REGULATORY INFORMATION DISTRIBUTION SYSTEM (RIDIS)

SUBJECT: Responds to IE Bulletin 80-06, "Engineered Safety Features (ESF) Reset Controls." Test procedures are being developed to test engineered safety feature equipment. Forwards oversize drawings. Seven drawings illegible.

June 17, 1980
LDR-80-159

RESPONSE TO NRC BULLETIN 80-06
ENGINEERED SAFETY FEATURES RESET CONTROLS

PROPOSED SYSTEM MODIFICATION #1

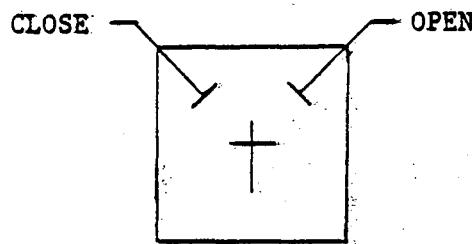
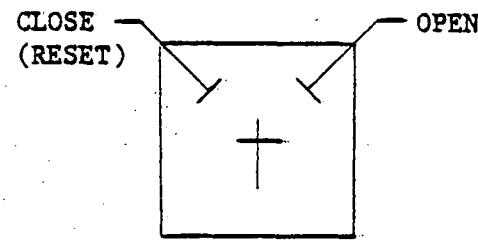
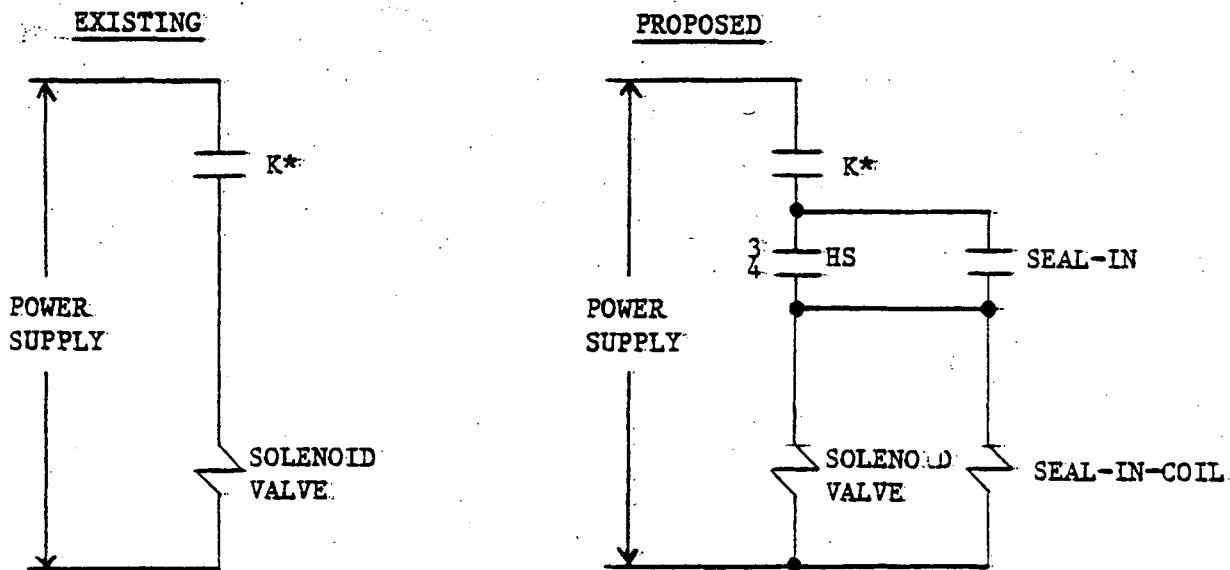
Existing Condition: The ESFAS signal contact K* (in series with a hand switch contact) opens, deenergizing the solenoid coil. Because the hand switch contact remains closed unless manually opened, reset of the ESFAS signal recloses the K* contact and reenergizes the solenoid coil.

Proposed Modification: Introduce a seal-in circuit consisting of a new relay and a contact from the existing hand switch. Connect a contact from this new relay in series with the ESFAS signal contact and the hand switch contact. Opening the ESFAS signal contact will deactivate the seal-in circuit and will prevent the solenoid coil from reenergizing upon ESFAS reset. The seal-in circuit can be reactivated by turning the hand switch to the "close/reset" position.

PROPOSED FIX: Use existing switch, add seal-in-coil, and reconnect as shown.

PROPOSED SYSTEM MODIFICATION #2

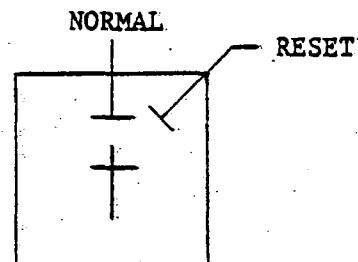
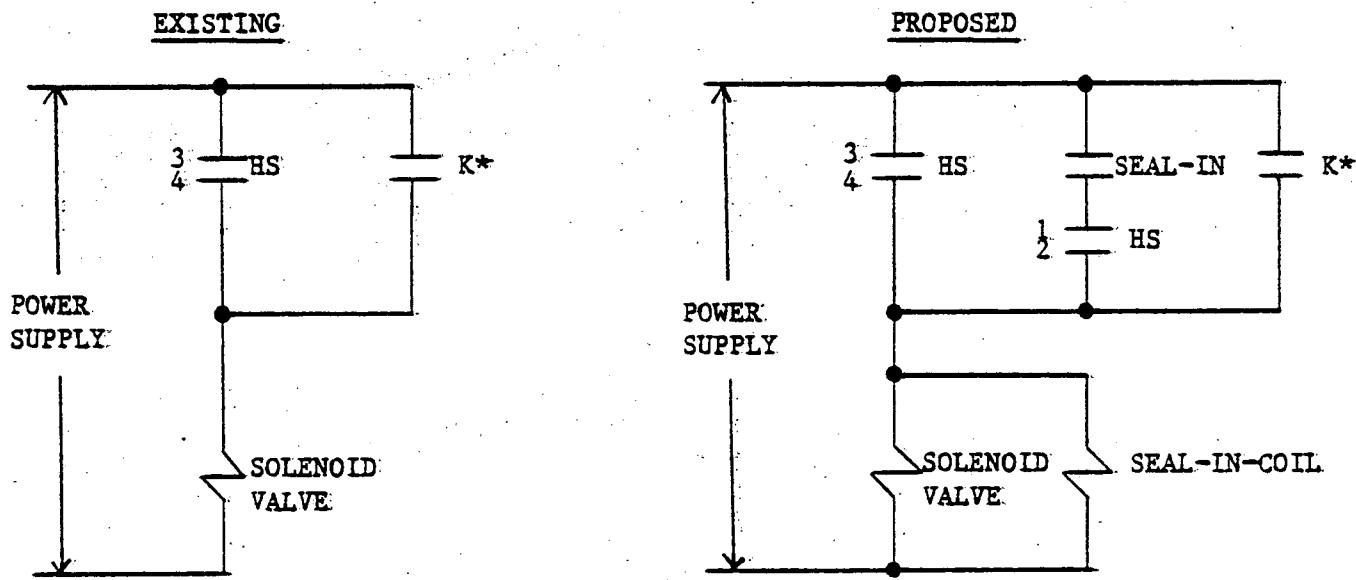
Existing Condition: The ESFAS signal contact K* opens, deenergizing the solenoid coil. Reset of the ESFAS signal closes this contact, reenergizing the solenoid coil. There is no other control (manual or automatic) for this circuit.

Proposed Modification: Introduce a seal-in circuit consisting of a new relay and a new "normal/reset" hand switch. Normally, the seal-in circuit remains activated through the ESFAS signal contact. When the ESFAS signal contact opens, it will deactivate the seal-in circuit and will prevent the solenoid coil from reenergizing upon ESFAS reset. The seal-in circuit can be reactivated by turning the new hand switch to the "reset" position.

PROPOSED FIX: Add the Hand Switch (HS), seal-in-coil, and reconnect as shown.

PROPOSED SYSTEM MODIFICATION #3

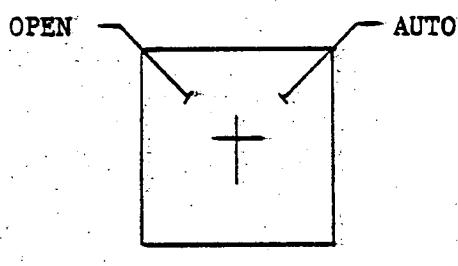
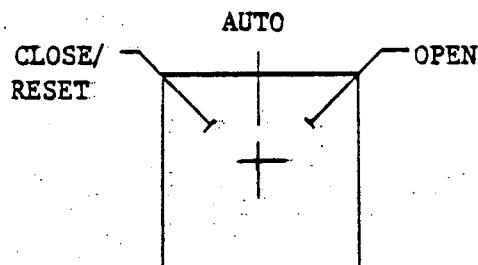
Existing Condition: The ESFAS signal contact K* (in parallel with a hand switch contact) closes, energizing the solenoid coil. Because the hand switch contact remains open unless manually operated, reset of the ESFAS signal deenergizes the solenoid coil.

Proposed Modification: Replace the existing maintained-position hand switch with a three-position, spring-return-to-auto hand switch and introduce a seal-in circuit. When the ESFAS signal contact closes, it activates the seal-in circuit and prevents the solenoid coil from deenergizing upon ESFAS reset. The seal-in circuit can be deactivated by turning the hand switch to the "close/reset" position.

PROPOSED FIX: Replace the existing switch with a new switch, add seal-in-coil, and reconnect as shown.

PROPOSED SYSTEM MODIFICATION #4.

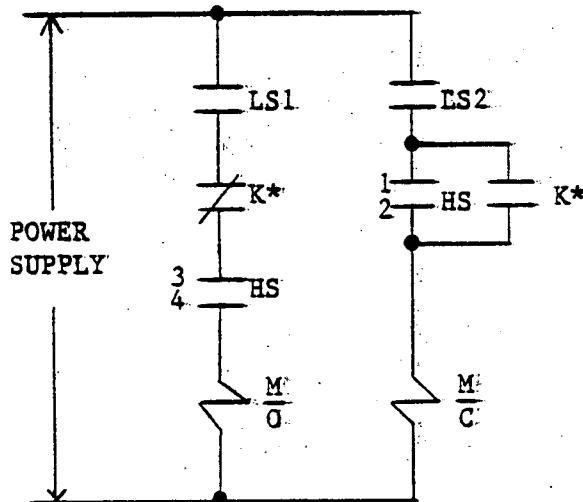
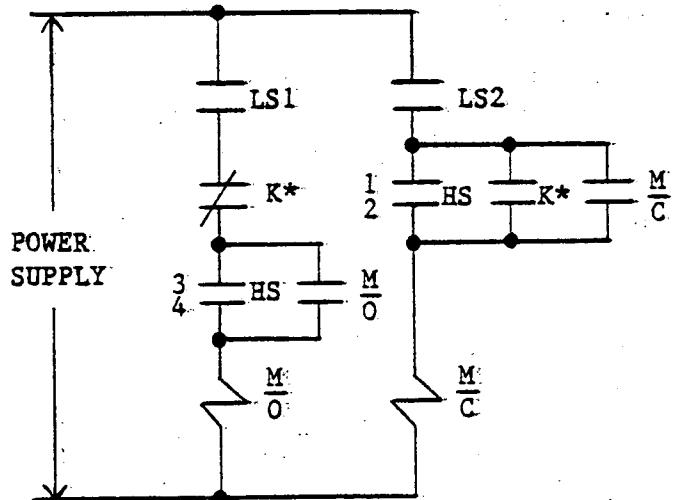
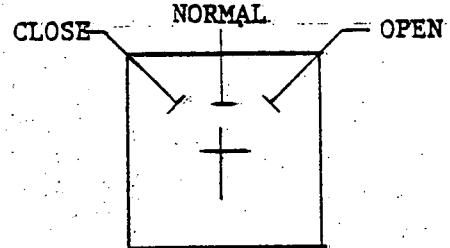
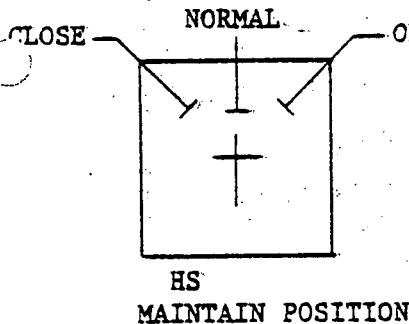
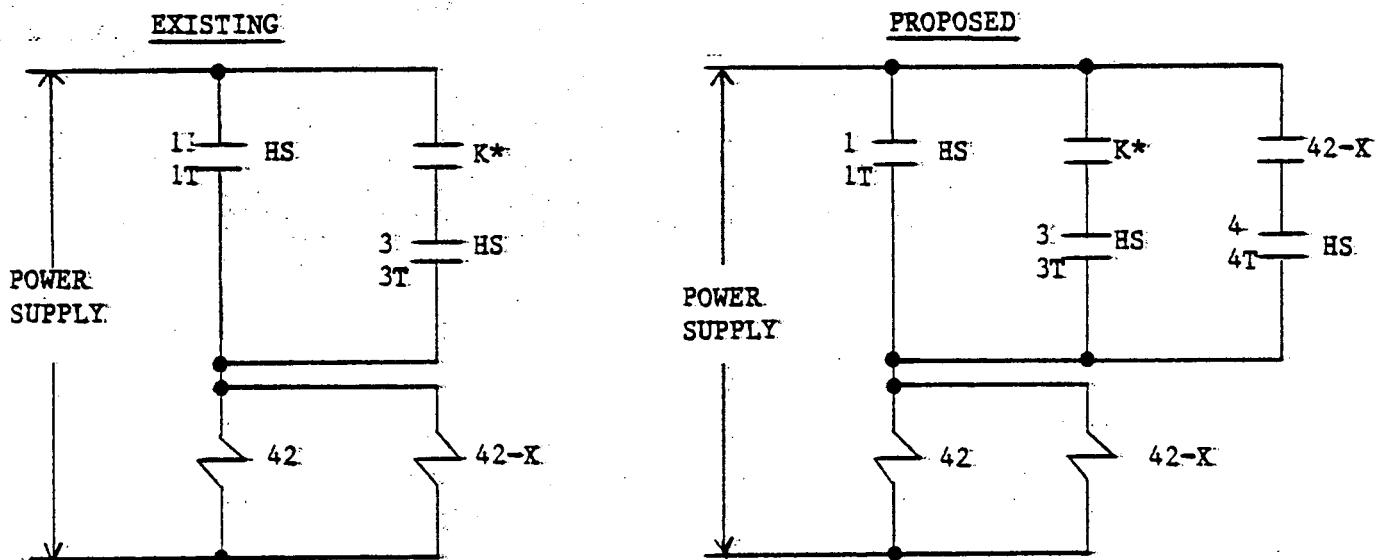
Existing Condition: This circuit uses two separate motor starter coils for opening and closing a motor-operated valve. A normally closed ESFAS signal contact K* is wired in series with a maintained hand switch contact and the opening coil. A normally open ESFAS signal contact K* is wired in parallel with a maintained hand switch contact and then in series with the closing coil. Upon receipt of an ESFAS signal, both contacts change state, thus energizing the closing coil. If the valve was initially open, the hand switch contacts remain in their original position, and reset of the ESFAS signal will energize the opening coil and reopen the valve.

Proposed Modification: Replace the existing maintained position switch with spring-return-to-normal switch and introduce a seal-in circuit using auxiliary contacts from the opening and closing coils. The seal-in circuit is deactivated when the limit switch contact opens at the end of the travel of the valve, preventing the opening coil from energizing upon ESFAS reset. A manual action of the hand switch is required to energize the opening coil.

PROPOSED FIX: Replace the existing maintain position switch with new spring return to "Normal" switch. Reconnect as shown.

PROPOSED SYSTEM MODIFICATION #5

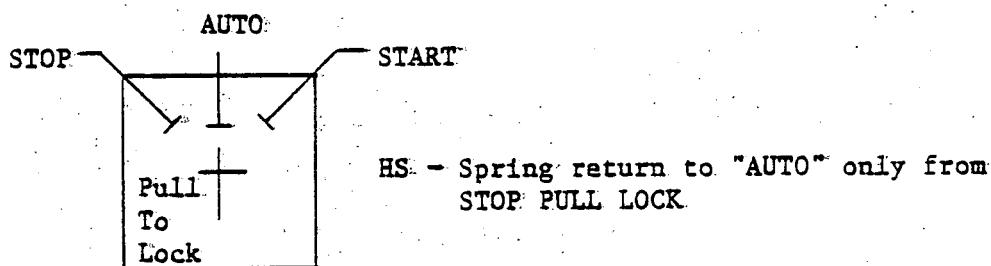
Existing Condition: The ESFAS signal contact K* (in series with a closed-in-auto contact from the hand switch) closes, energizing the starter coil. When the ESFAS signal contact opens upon ESFAS reset, the starter coil deenergizes.

Proposed Modification: Introduce a seal-in circuit using spare contacts from existing auxiliary relay and existing hand switch. When the ESFAS signal contact closes, it activates the seal-in circuit and prevents the starter coil from deenergizing upon ESFAS reset. The seal-in circuit can be deactivated by turning the hand switch momentarily to the "stop" position.

PROPOSED FIX: Use existing switch, reconnect as shown.
